March 24, 2014

NOTICE OF ADDENDUM
ADDENDUM NO. 1
CONTRACT NO. 7206

STATE STREET RECONSTRUCTION
ASSESSMENT DISTRICT 2014

1
S-4
STREETSCAPE PLAN - 700 BLOCK
1"=20' @ 11X17

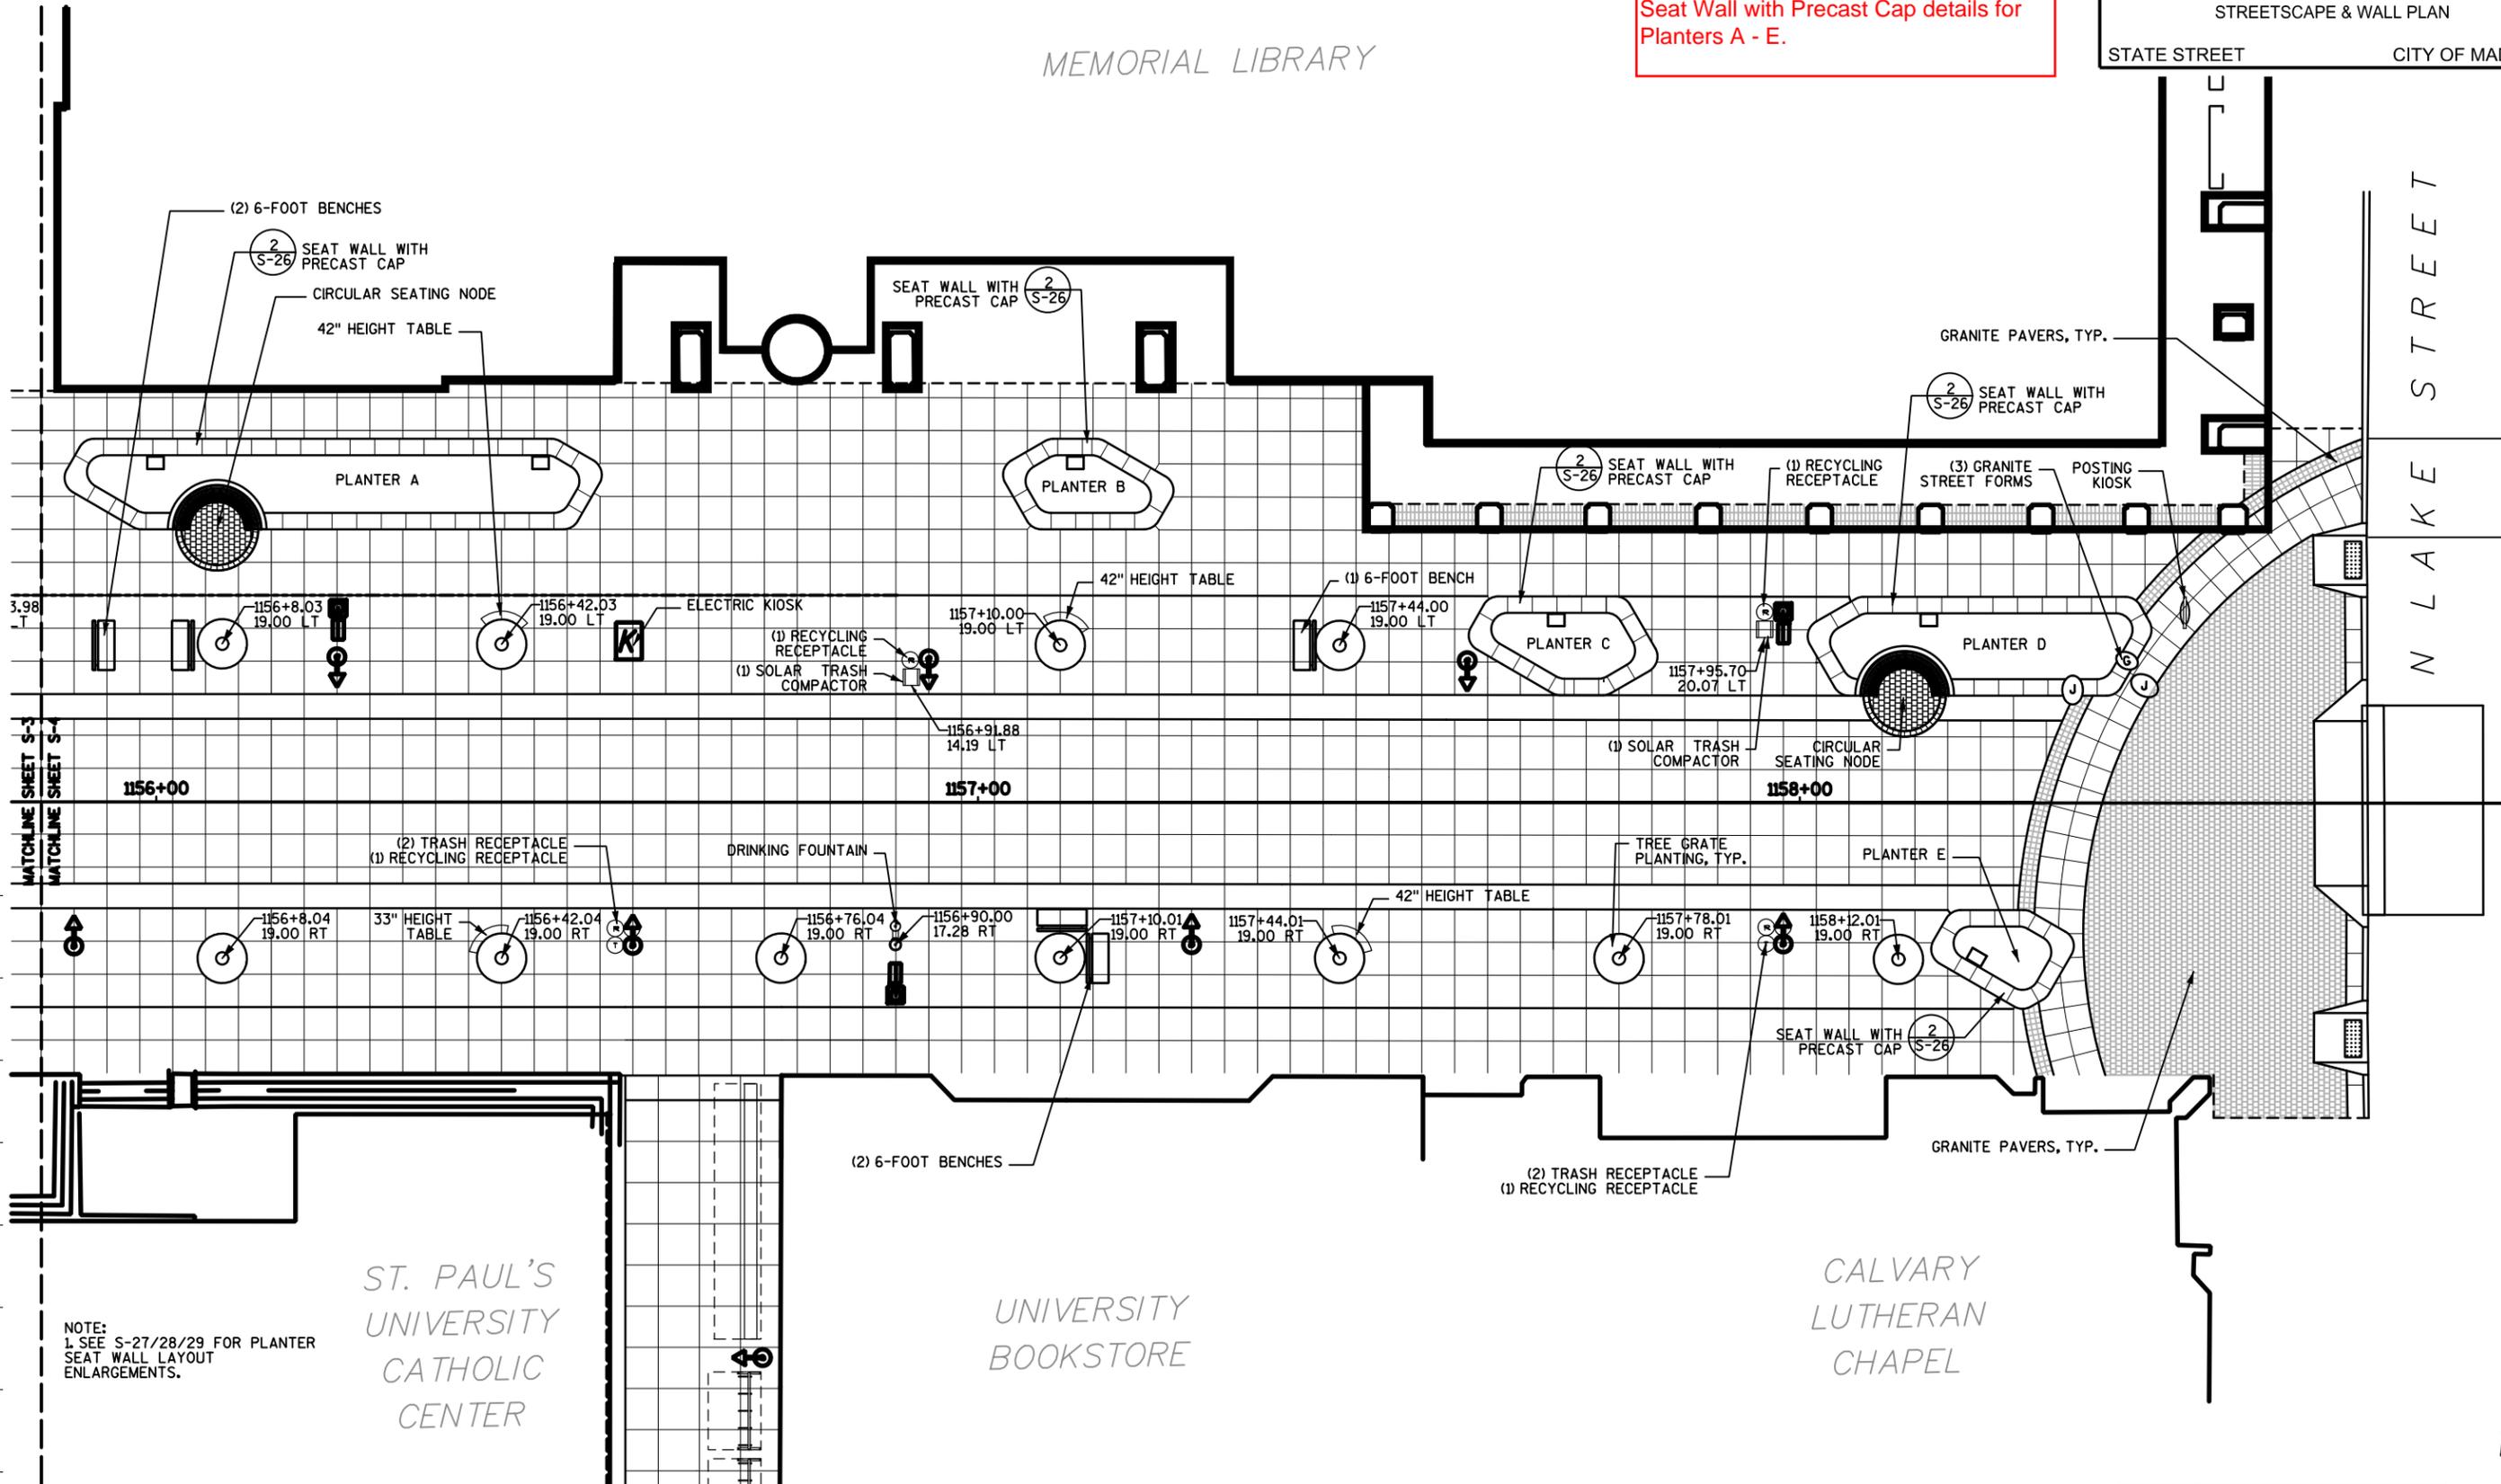
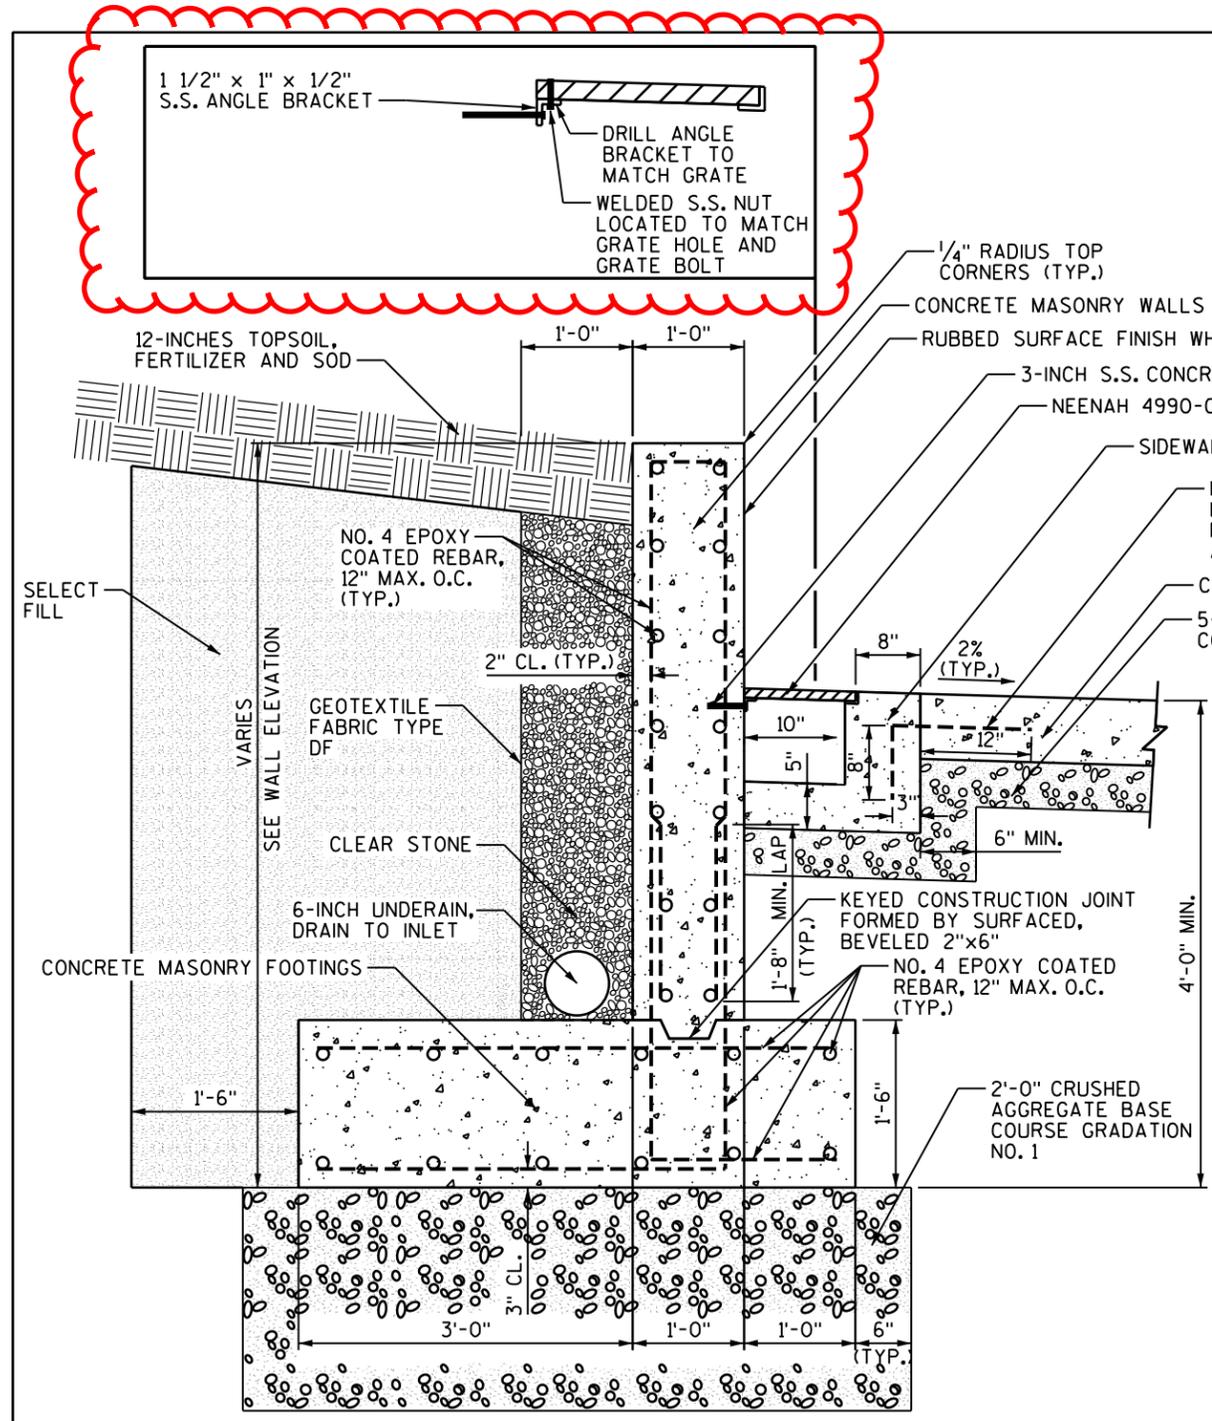
Replace Sheet S4 (Revised 3/21/14) – Added callouts for Seat Wall with Precast Cap in planter condition.

REVISED 3/21/14: Added call outs for
Seat Wall with Precast Cap details for
Planters A - E.

1 CAST-IN-PLACE CONCRETE RETAINING WALL @ BASCOM MALL
S11 SCALE: NONE

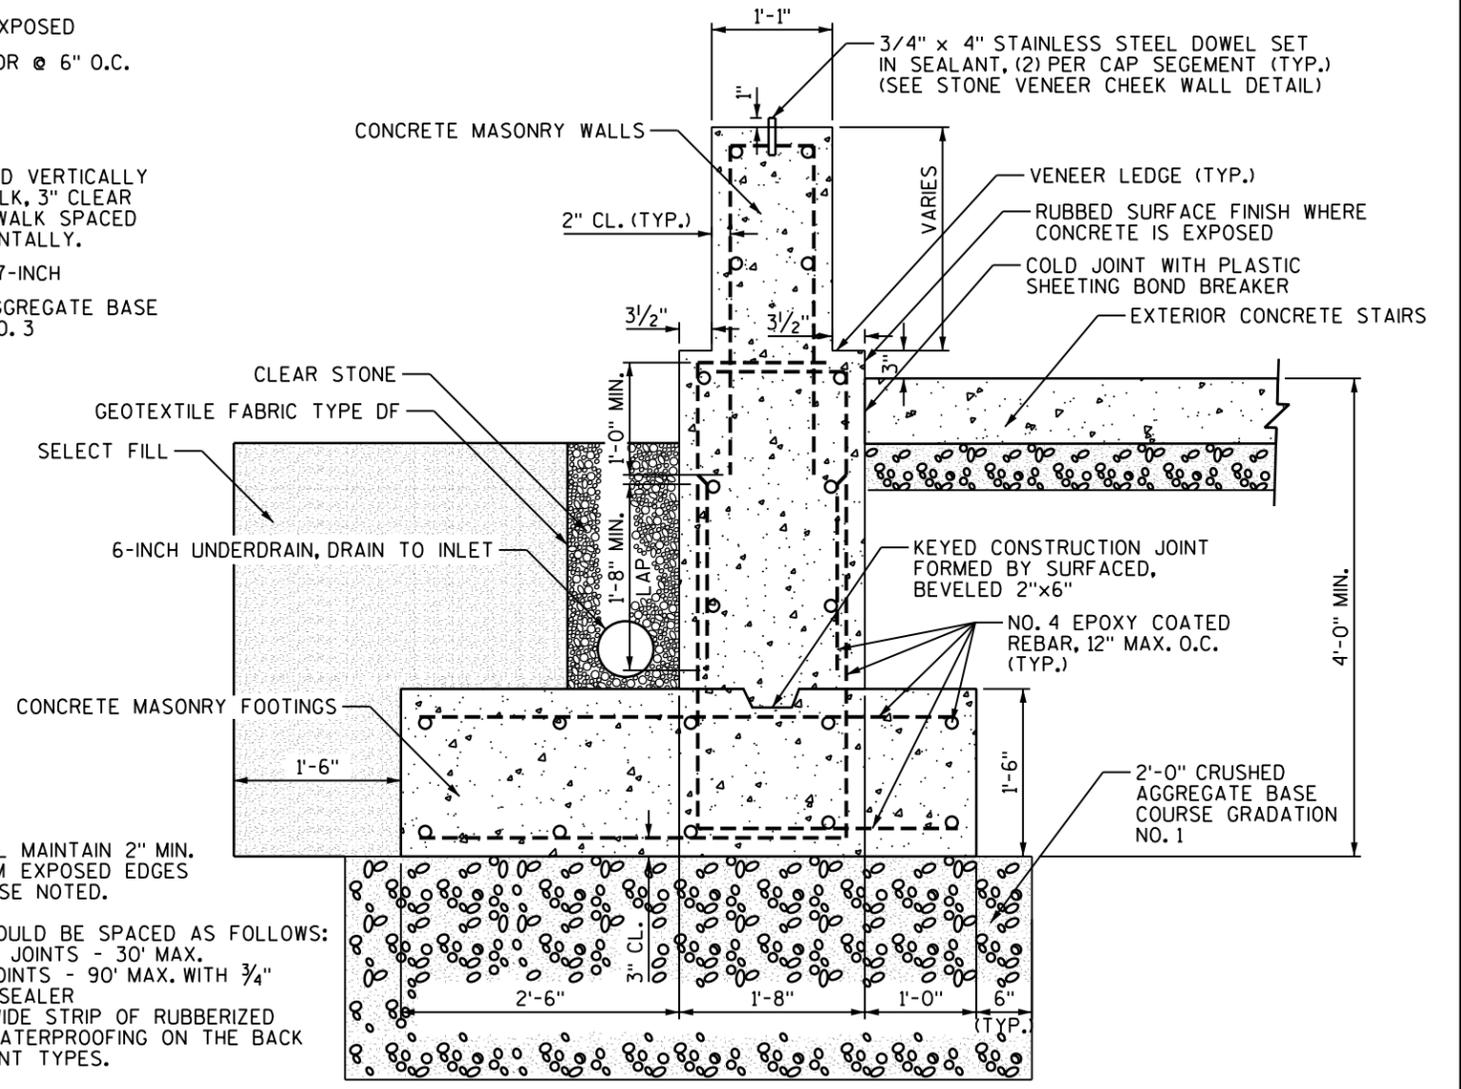
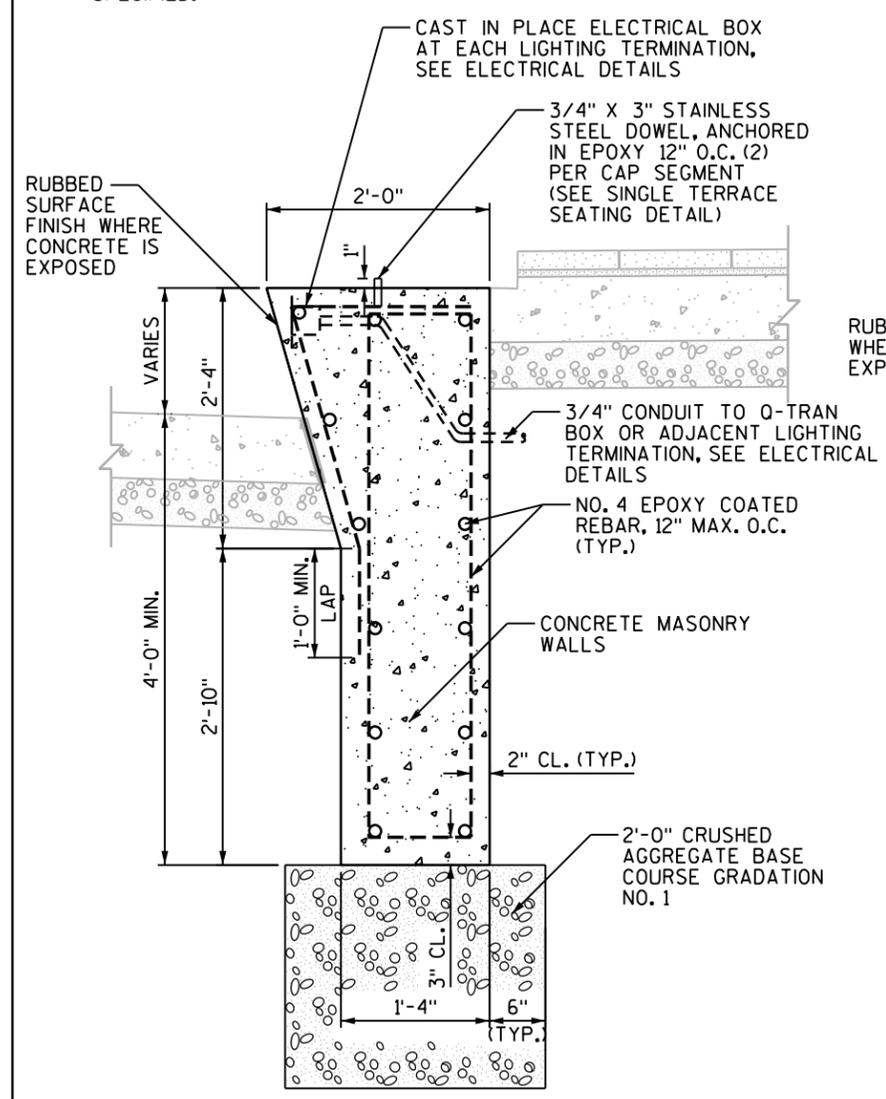
Replace Sheet S11 (Revised 3/21/14) – Added detail for the Sidewalk Drain installation.

REVISED 3/21/14: Added angle bracket detail for installing angle bracket to CIP concrete wall

1 SINGLE TERRACE SEATING WALL DETAIL
S19 SCALE: NONE

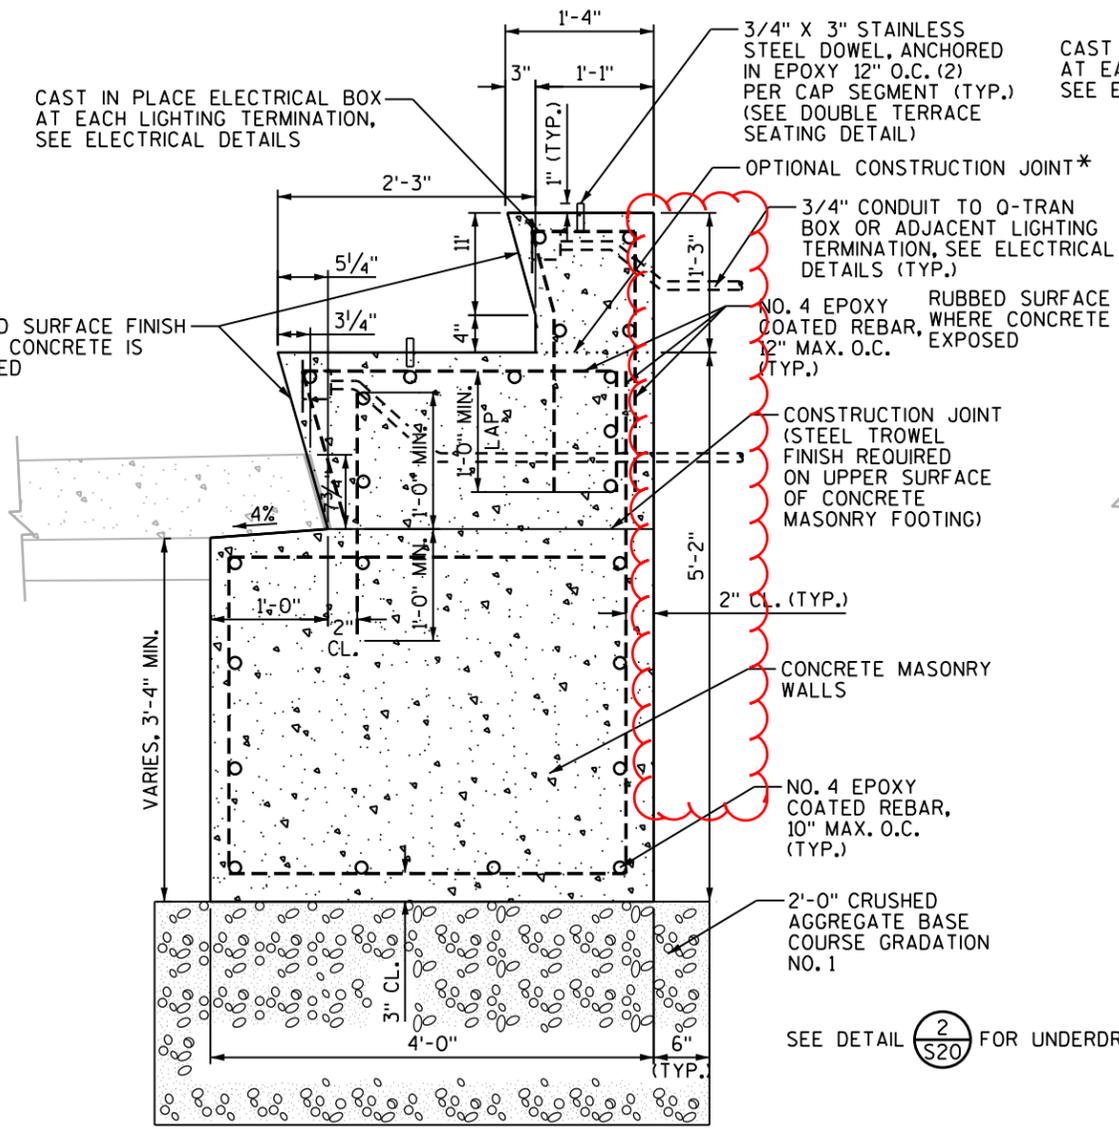
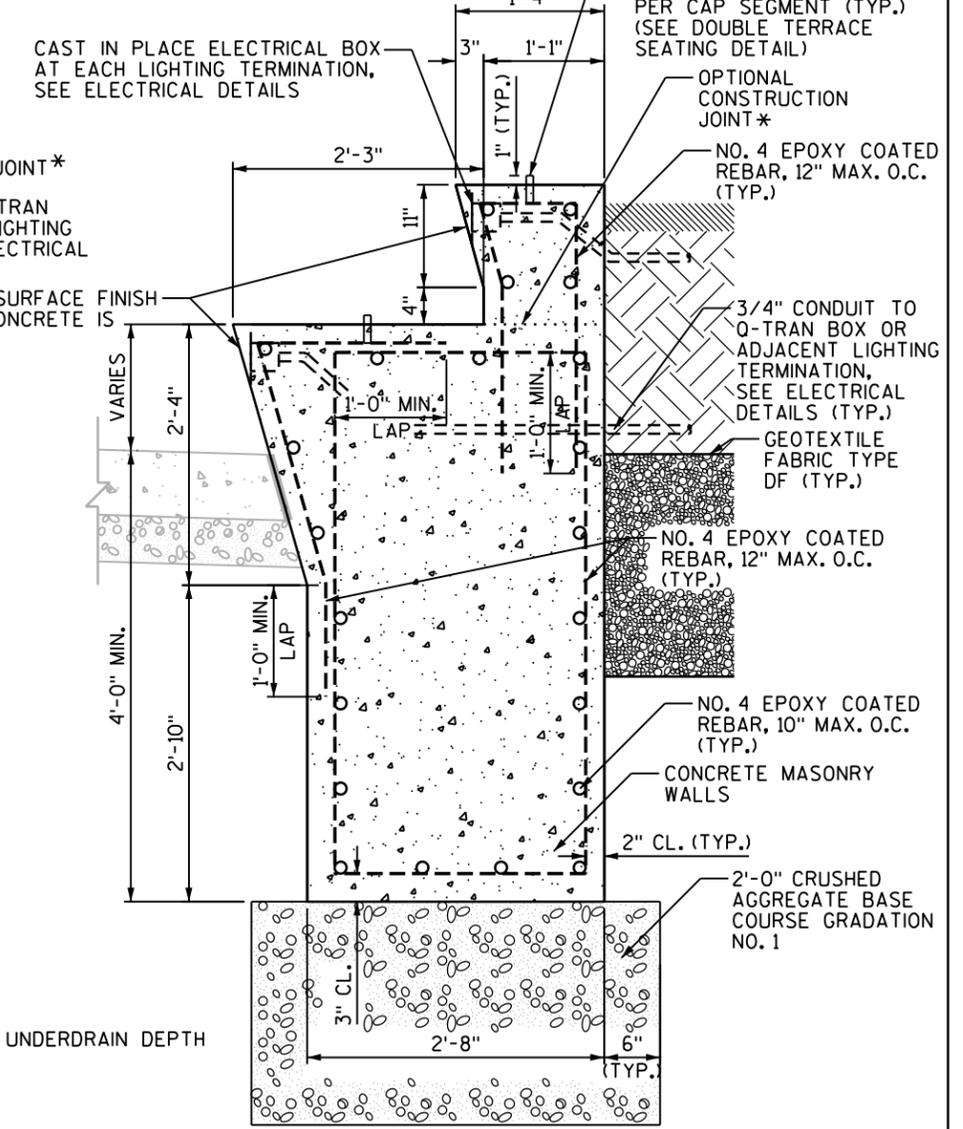
Replace Sheet S19 (Revised 3/21/14) – Remove clear stone & plant mix from back of wall along Library Mall

Revised 3/21/14 - Removed Clear Stone and Planter Mix
